D3290-041 REPLACEMENT WINDOW ASSEMBLY

DRAWING NO. REV. C
D3290 SHEET 1 OF 2

DRAWING NO. D3290	TITLE REPLACEMENT WINDOW ASSEMBLY	REV. C	DART AEROSPACE LTD ENGINEERING ORDER		D.E.O. NO. D3290-C-1	SHEET NO. SHEET 1 OF 1	SCALE NTS
DRAWN <i>q</i>	CHECKED <i>1</i>	MFG. APPR. <i>E</i>	APPROVED <i>NP</i>		DE APPR. <i>#</i>		
DATE 09.09.18	DATE 09.09.18	DATE 09.09.18	DATE 09/09/21		DATE 09/09/21

CHANGE MATERIAL THICKNESS OF D3290-1 FRAME TO 0.063 FROM 0.040. REF PAR 09-033.

D3290-1 FRAME

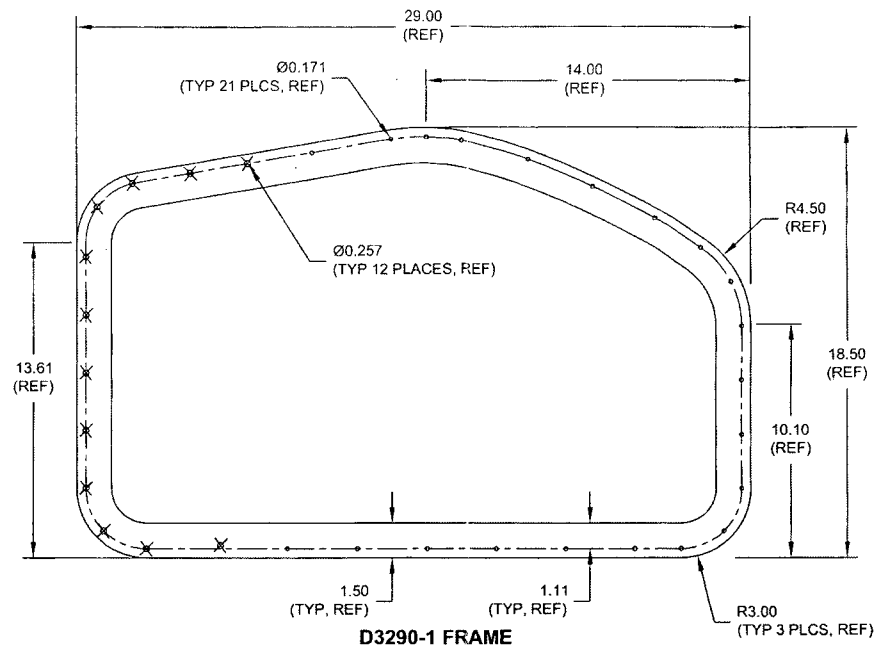
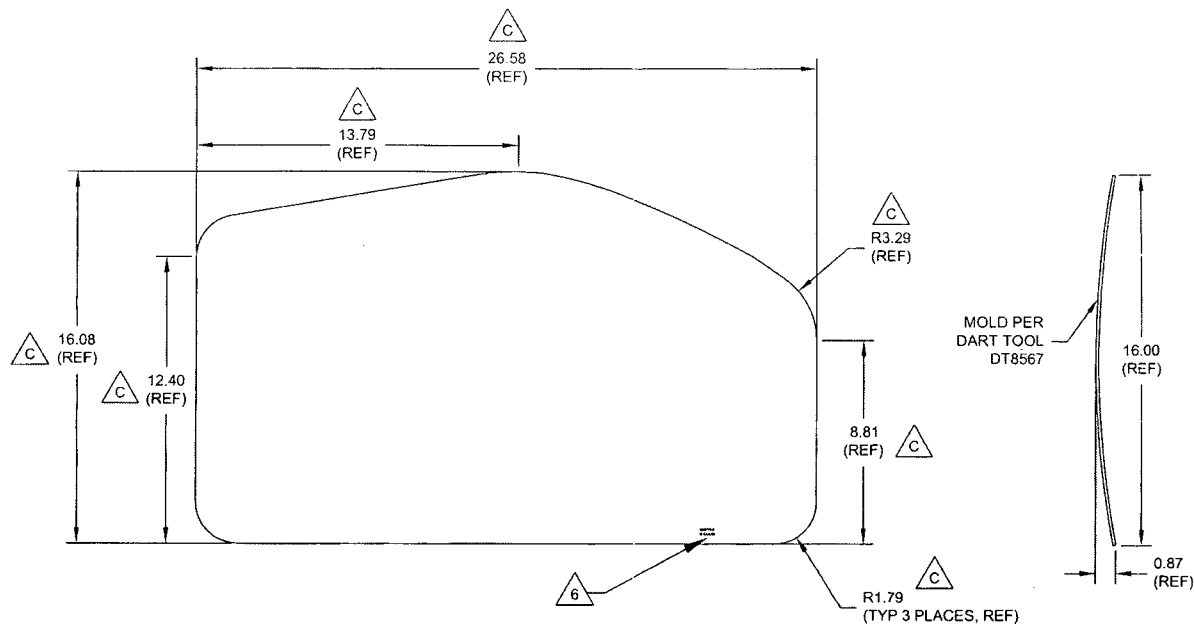
MATERIAL CALL-OUT OF D3290-1 FRAME ON SHEET 1 IS AMENDED AS FOLLOWS:

- 1) MATERIAL: 6061-T6 (OR 6061-T62) ALUMINUM SHEET ~~0.040 THICK~~ 0.063 THICK (REPLACE)
 PER AMS-QQ-A-250/11 OR AMS 4025 OR AMS 4027
~~(REF. DART SPEC. M6061T6S.040)~~ REF. DART SPEC. M6061T6S.063 (REPLACE)
 OR
 5052-H32 ALUMINUM SHEET ~~0.040 THICK~~ 0.063 THICK (REPLACE)
 PER AMS-QQ-A-250/8 OR AMS 4016
~~(REF. DART SPEC. M5052H32S.040)~~ REF. DART SPEC. M5052H32S.063 (REPLACE)
